REV.
A

(R) FITTING ASSEMBLY, ELBOW, 90°,
BEAM SEAL, RETAINED NUT

AS4807
SHEET 1 OF 3

FIGURE 1 - FITTING ASSEMBLY, ELBOW, 90°

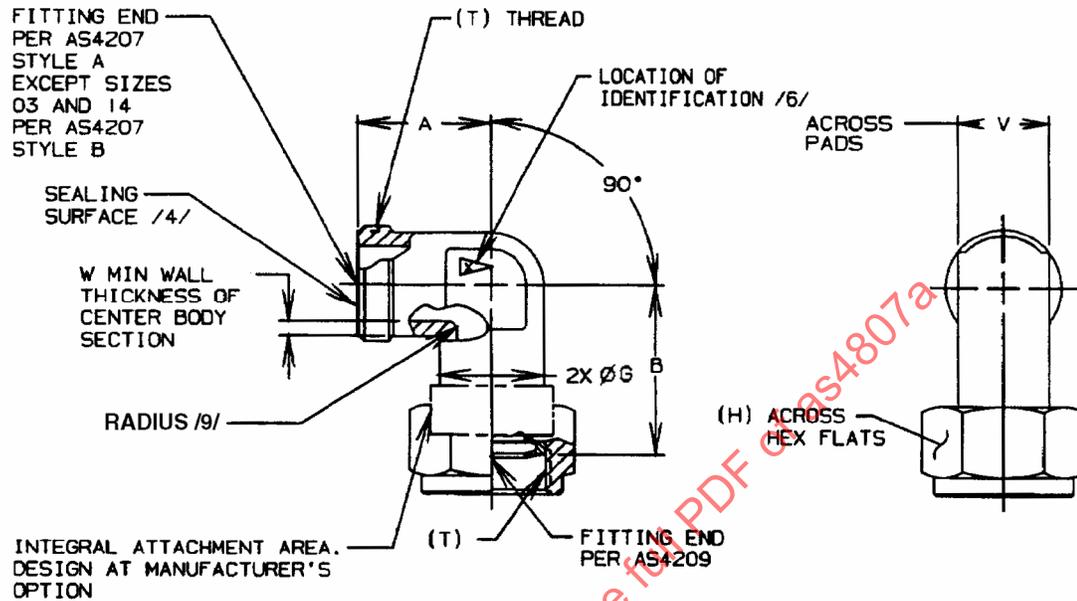
THIS STANDARD HAS BEEN REVISED TO CORRECT THE AS-FORGED LEG DIMENSION TO ALLOW STANDARD TOLERANCE FORGINGS TO BE USED AND STILL MEET THE SPECIFICATION.
